# Warranty Field Campaign

<b>Campaign Number:</b> c2024	<b>Revision:</b> A	<b>Released Date:</b> 13-Jun-2018
<b>L9 2017 VG Turbo Speed Sensor Harness Routing Campaign</b>		<b>Expiration Date (U.S. and Canada):</b> 27-Apr-2020
		<b>Expiration Date (International):</b> 27-Apr-2020

## L9 2017 VG Turbo Speed Sensor Harness Routing Campaign

Image A – Incorrect routing

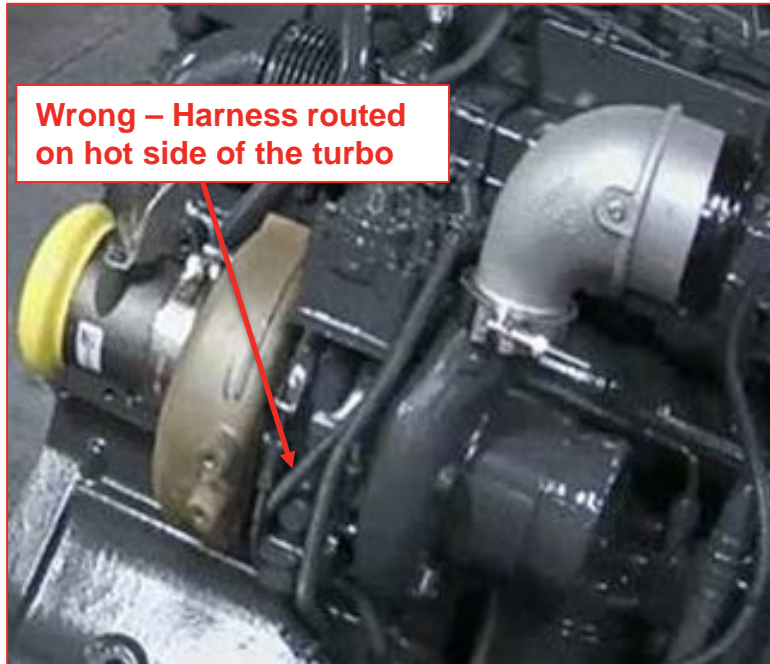
This campaign is being issued to address an incorrectly routed turbocharger speed sensor harness on certain L9 CM2350 L116B and L123B Engines, and authorizes the field to replace the harness and route correctly.

1. Remove and Install the Turbo speed sensor harness PN 4034198. Please refer to the appropriate Service Manual, Section 019-390 Turbocharger Speed Sensor.
2. Please refer to Attachment B. Route the new harness as illustrated in Routing Image B.

Image B – Correct routing
